U.S. DEPARTMENT OF ENERGY
CERTIFICATE OF COMPLIANCE
For Radioactive Materials Packages

1a. Certificate Number	1b. Revision No.	1c. Package Identification No.	1d. Page No.	1e. Total No. Pages
USA/6387/BLF (DOE-RL)	2	USA/6387/BLF (DOE-RL)	1	5

SAFETY EVALUATION BY THE RICHLAND OPERATIONS
OFFICE FOR REVISION 2 TO THE
HEDL MODEL 60 SHIPPING
CONTAINER - USA/6387/BLF (DOE/RL)

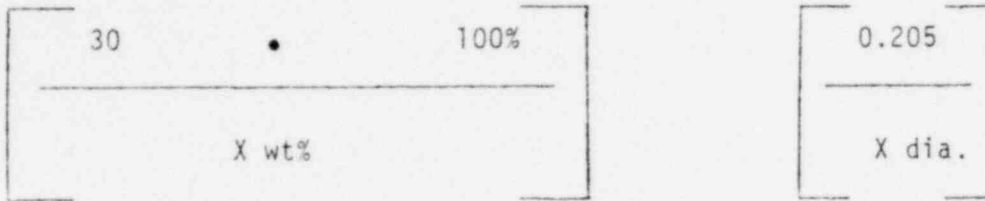
- The first change request that Table I of the certificate be revised to include higher enrichment and pin limit number combinations. The current certificate does not allow interpolation of pin limits with varying enrichment (Pu + ²³⁵U contents) range. The new table uses smaller incremental enrichment ranges, therefore, 37 additional pin combinations limits have been added.

The criticality analysis bases the total fissile density at 2 Kg fissile material per foot within the containment vessel (not to exceed 37 inches total fuel length).

With the 2,000 gm. of fissile material as the controlling limit the maximum pins limit is derived as follows:

The volume (per foot) of a pin in each "Fuel Column Diameter" section is calculated. The amount of plutonium in that one foot section is calculated using the theoretical density of PuO₂ as 11.46 gm/cm³ and the Pu being 88% of PuO₂. This gives the Pu per gm/cm³ then multiplied by the volume of one foot of the pin give the total Pu in the one foot section. When the amount of Pu in that pin is divided into the 2,000 gm limit, the maximum pins limit number is determined.
